Scale Pads/City Reclamation
L.R. Higgins

**CITY OF PORTLAND, MAINE
DEVELOPMENT REVIEW APPLICATION
PLANNING DEPARTMENT PROCESSING FORM**

City of Portland, Maine
Supplemental Submission, Site Plan Application
Riverside Transfer Station
Portland, Maine
St. Germain File No.: 2844.1

SOLID WASTE BUILDING NORTH ELEVATION
Scale: 1/2" = 1'-0"

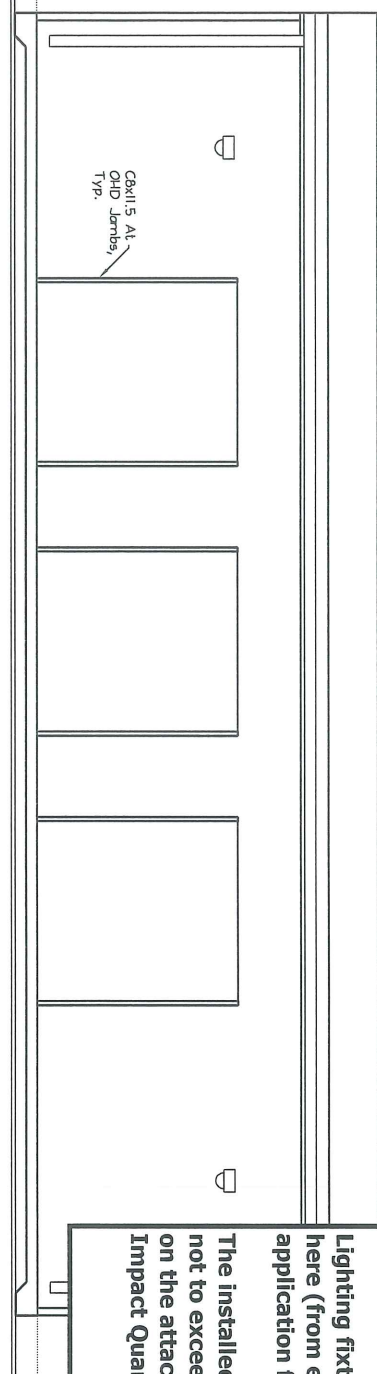
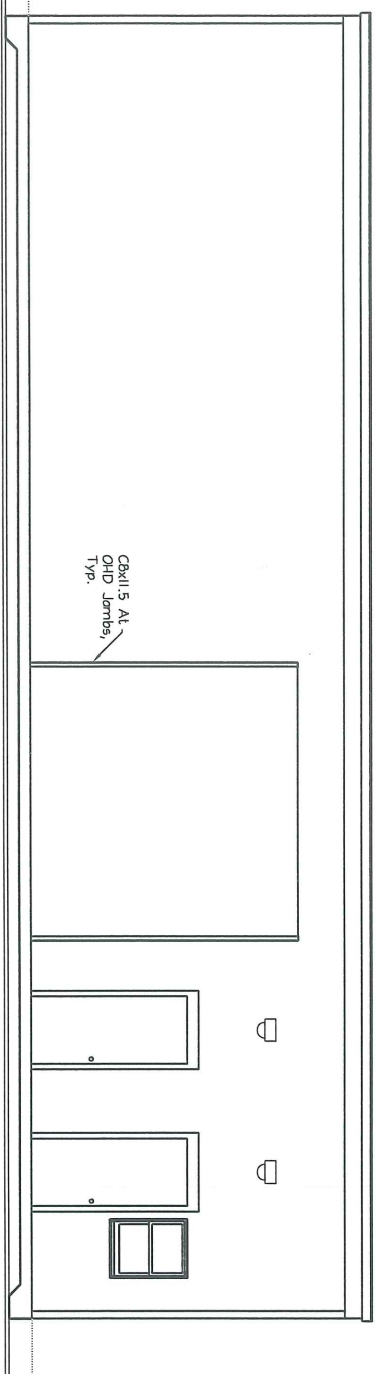
Lighting fixtures will differ from those shown here (from elevations submitted with the application for building permit in May 2007).

The installed fixtures will be cut-off fixtures, not to exceed 250 watts such as those shown on the attached specification for Lumark IP Impact Quarter Sphere fixtures.

SOLID WASTE BUILDING EAST ELEVATION
 Scale: 1/4" = 1'-0"

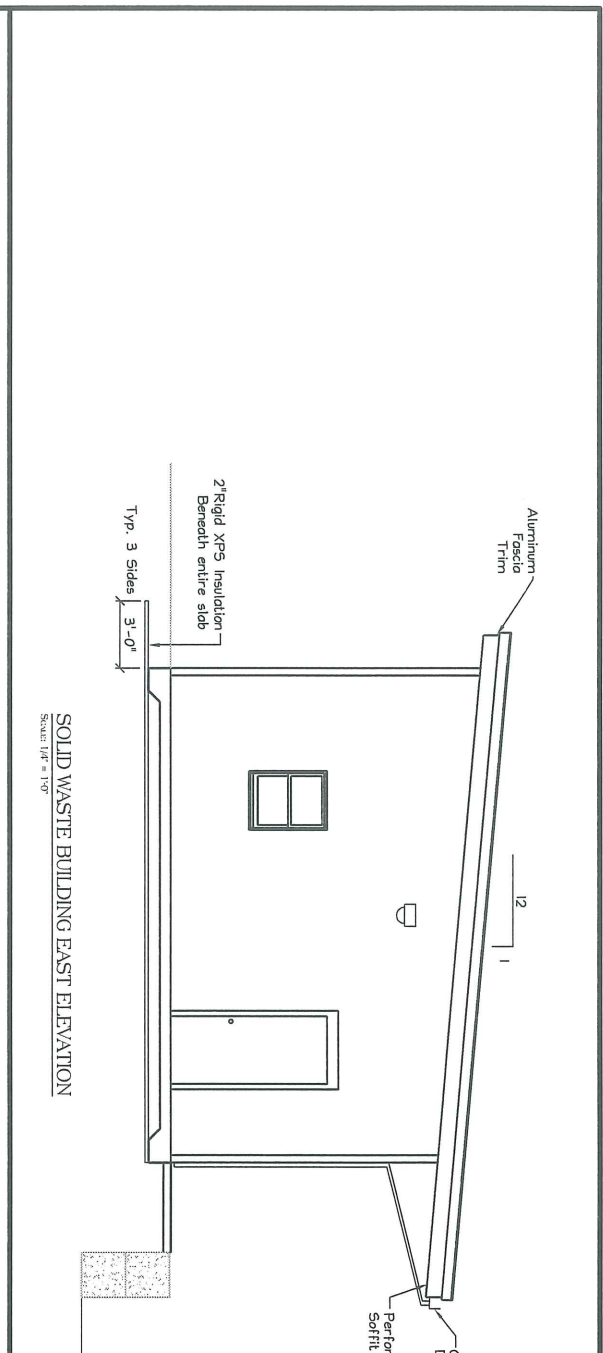
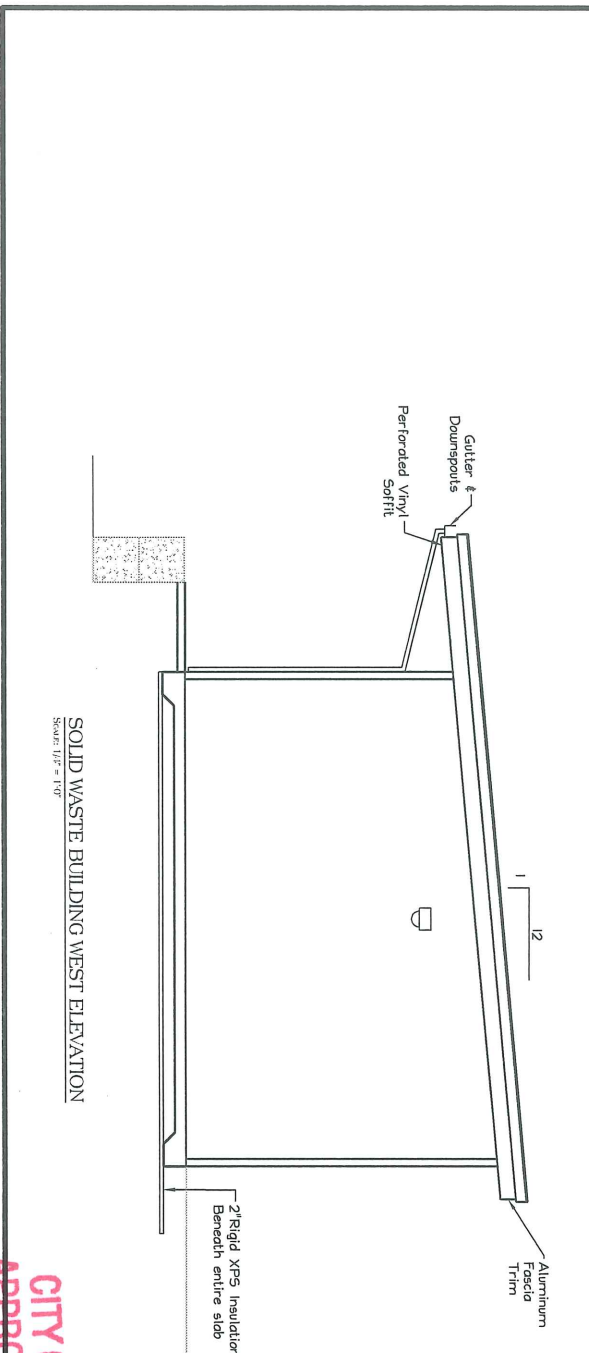
Lighting fixtures will differ from those shown here (from elevations submitted with the application for building permit in May 2007).
 The installed fixtures will be cut-off fixtures, not to exceed 250 watts such as those shown on the attached specification for Lumark IP Impact Quarter Sphere fixtures.

FIGURE 3
UNIVERSAL WASTE BUILDING
SOUTH ELEVATION
 CITY OF PORTLAND
 SOLID WASTE TRANSFER FACILITY
 RIVERSIDE STREET
 PORTLAND, MAINE

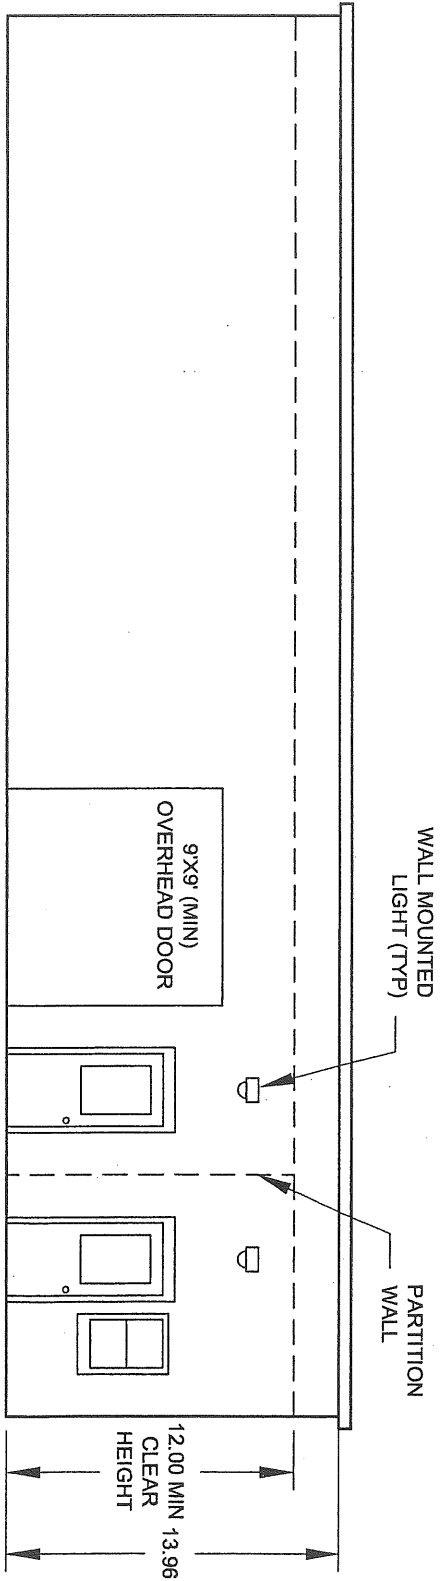
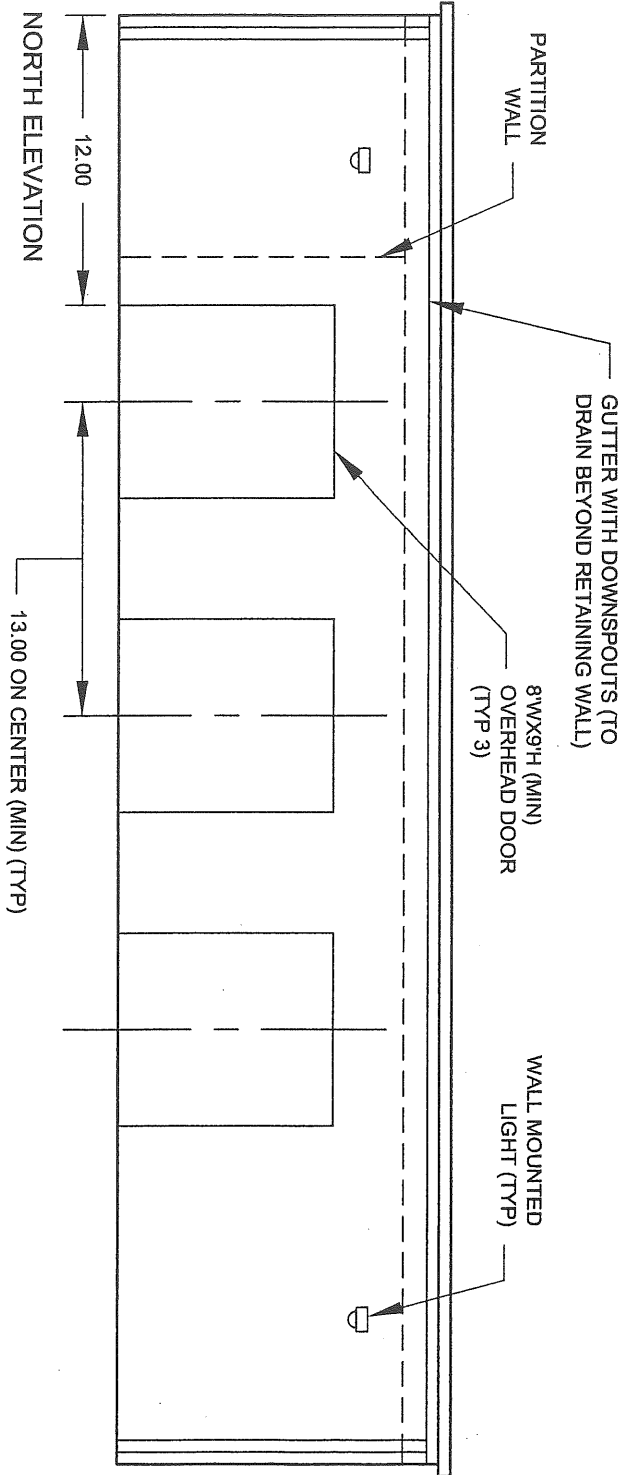
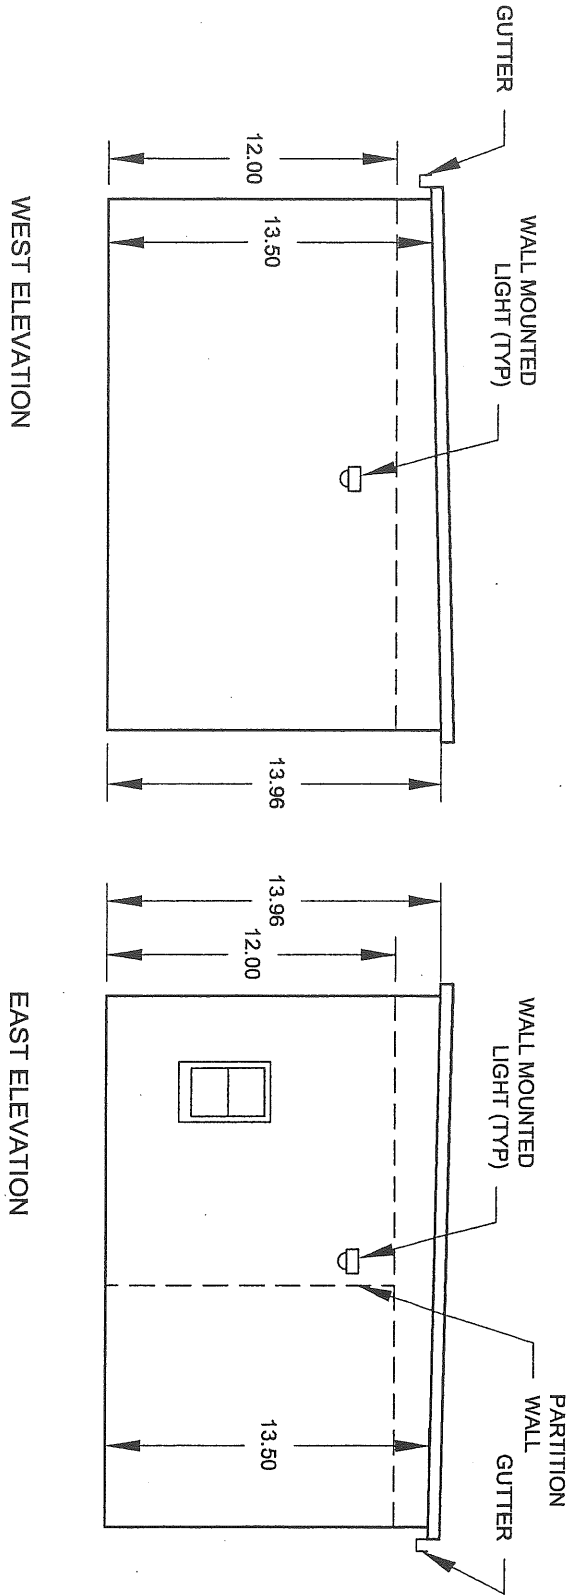
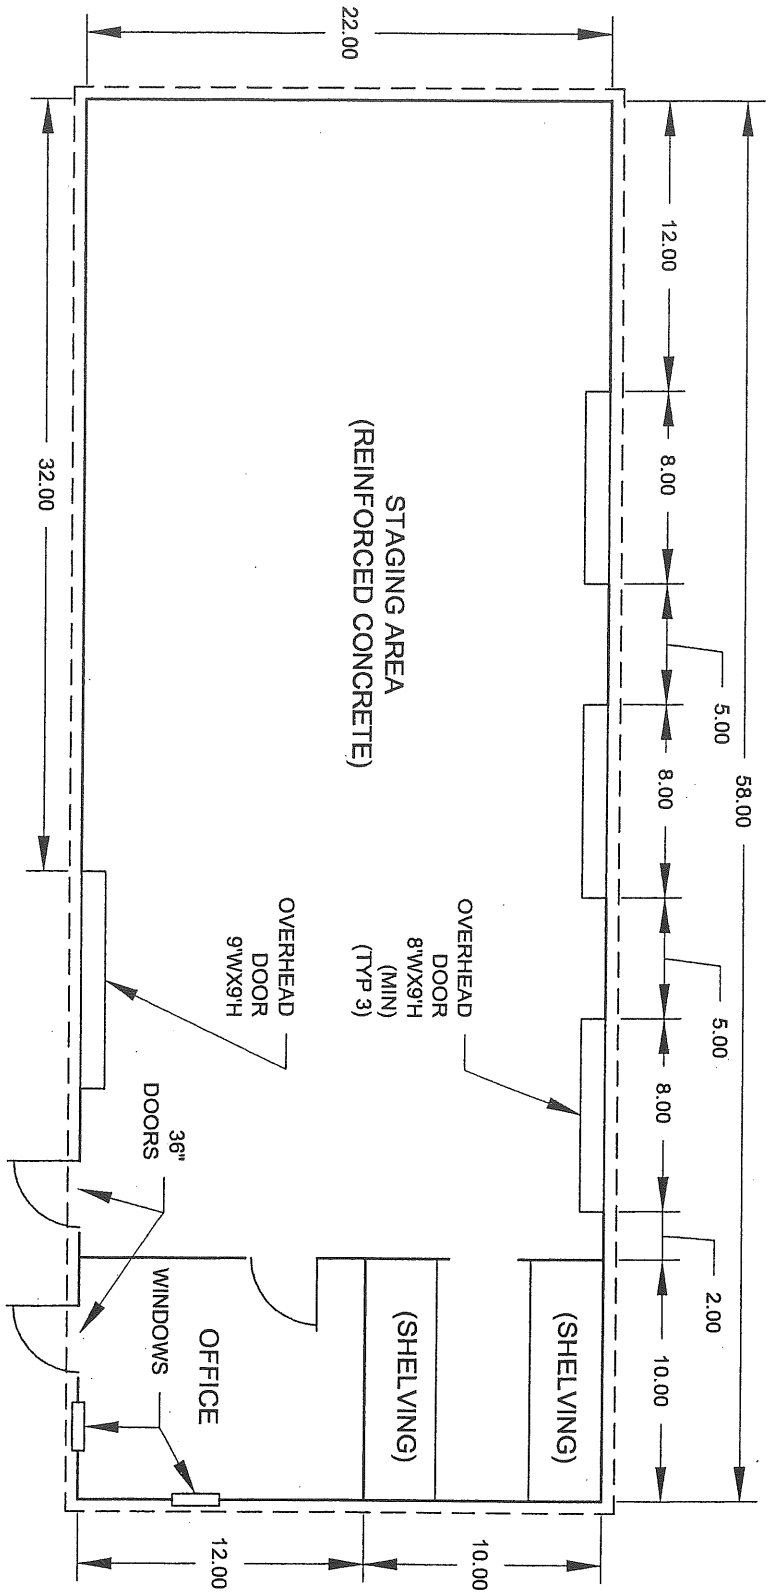
The detailed elevations and plans were submitted in Feb 07 and on March 27, 2007 I confirmed that they were acceptable except in respect to the lighting and that cut off lighting (in compliance with PV standards) should be installed to avoid glare to drivers and others using or near the site. I included the PV standards and anticipated confirmation of a revised lighting fixture or other information (so far not seen).

(4) Barbara, The building elevations as submitted are significantly different from the elevations submitted at site plan, has this been approved?

- no elevs of any bldg submitted with site plan
- was condition
- details submitted + approved except lightning
